Agenda Item # 3 SUB-003180-2024

Mobile Terrace Subdivision, Resubdivision of Lots 1-5,
Block 23

- Subdivision approval to create three (3) legal lots of record from five (5) legal lots of record.

APPLICATION NUMBER 3 DATE January 16, 2025

DETAIL SITE PLAN

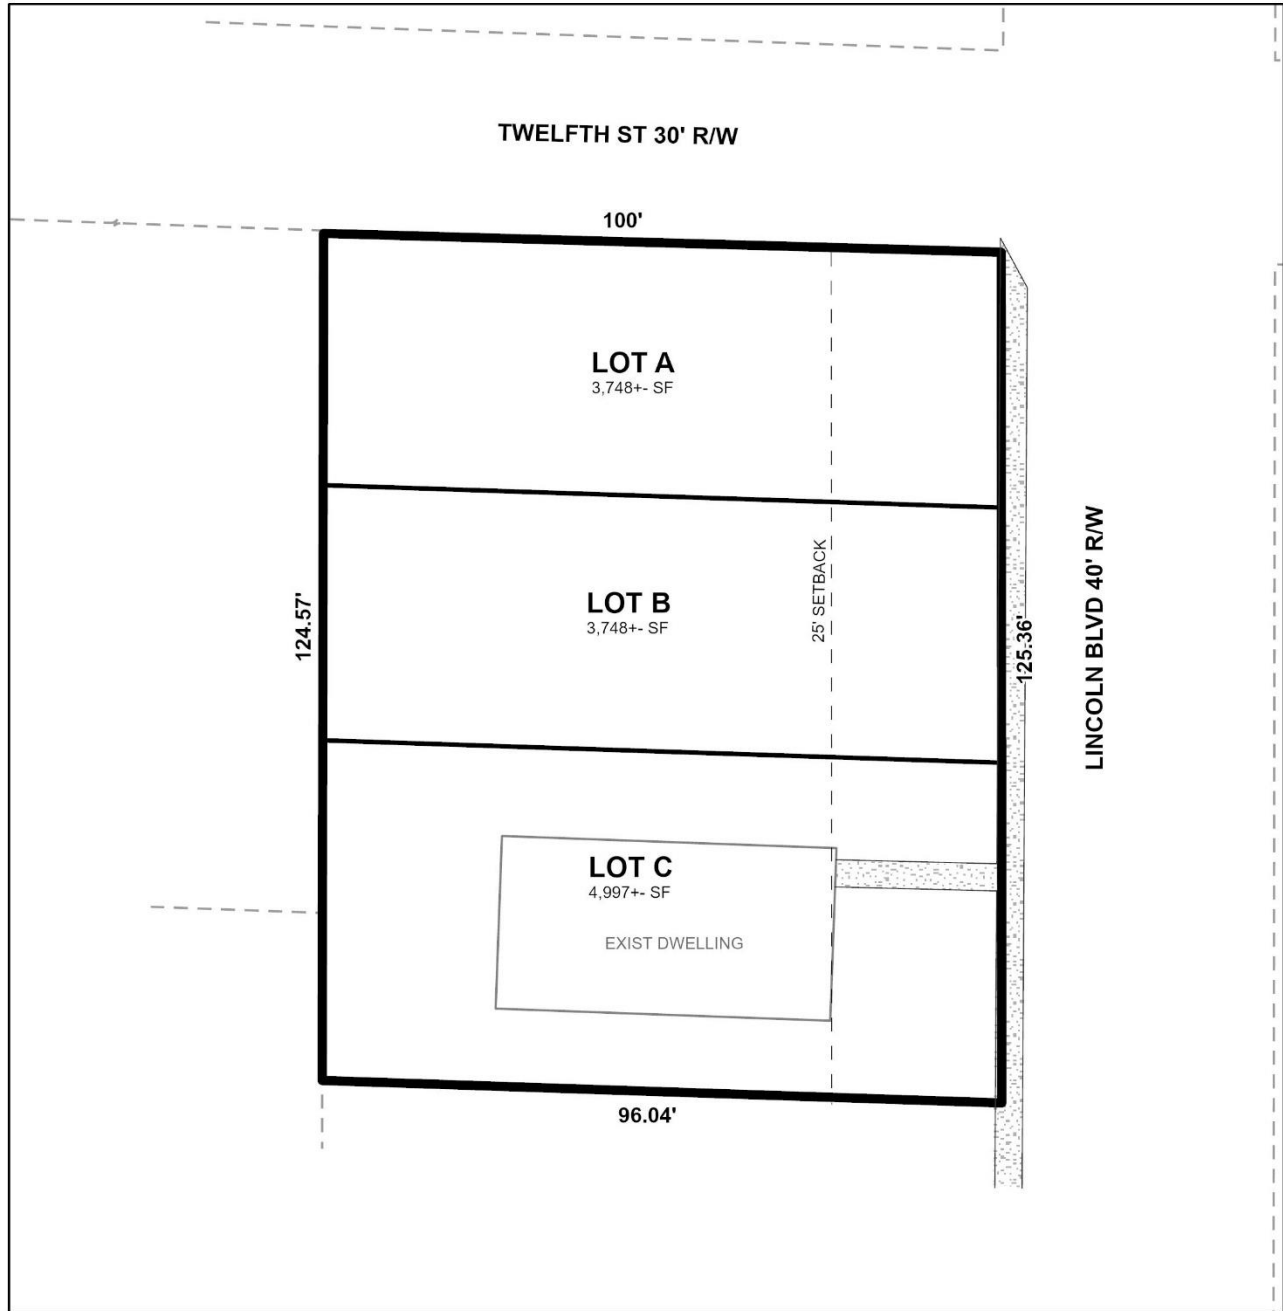
Proposed Lot A has frontage along Twelfth Street and Lincoln Boulevard, while proposed Lots B and C have frontage along Lincoln Boulevard. Both streets are minor streets with asphalt wing gutters, each requiring a 50-foot-wide right-of-way, per Section 6.B.9. of the Subdivision Regulations. The preliminary plat depicts a substandard, 30-foot-wide right-of-way along Twelfth Street, and a 40-foot-wide right-of-way along Lincoln Boulevard. Previous subdivision approval required dedication sufficient to provide 30 feet from the centerline of each street, but it should be noted that the substandard right-of-way widths are existing, and the 60-foot right-of-way requirement is for streets with open ditch drainage. Two (2) nearby subdivision approvals in 2012 and 2013 along Thirteenth Street only required 50-foot right-of-way widths.

Lot A is a corner lot requiring a 25-foot radius (or as approved by the City Engineer and the Traffic Engineering Director) where Twelfth Street and Lincoln Boulevard intersect, per Section 6.C.6. of the Subdivision Regulations. Revision of the plat to depict sufficient dedication of the corner radius should be required, if approved.

The lots, as proposed, do not meet the minimum area and width requirements of Sections 6.C.1.2.(a)(1) and 6.C.2.(b)(2) of the Subdivision Regulations for lots served by public water and sanitary sewer in an R-1, Single-Family Residential Suburban District. Such a design is not uncommon for lots within the surrounding neighborhood, having originally been platted with 25-foot wide by 100-foot-deep lots, suggesting a waiver of Sections 6.C.2.(a)(1) and 6.C.2.(b)(2) may be appropriate.

No front yard setback is illustrated along Twelfth Street. As such, if approved, the plat should be revised to illustrate a 25-foot front yard setback along Twelfth Street, adjusted for any required dedication.

1. Revision of the plat to illustrate dedication sufficient to provide 25-feet from the centerline of Twelfth Street and Lincoln Boulevard;
2. Revision of the plat to illustrate dedication of a 25-foot corner radius at the intersection of Twelfth Street and Lincoln Boulevard, per Section 6.C.6. (or as approved by the City Engineer and the Traffic Engineering Director);

4. Retention of the 25-foot front yard setback along Lincoln Boulevard;
5. Revision of the plat to illustrate a 25-foot front yard setback along Twelfth Street, per Section 5.C.2(i), adjusted for dedication;
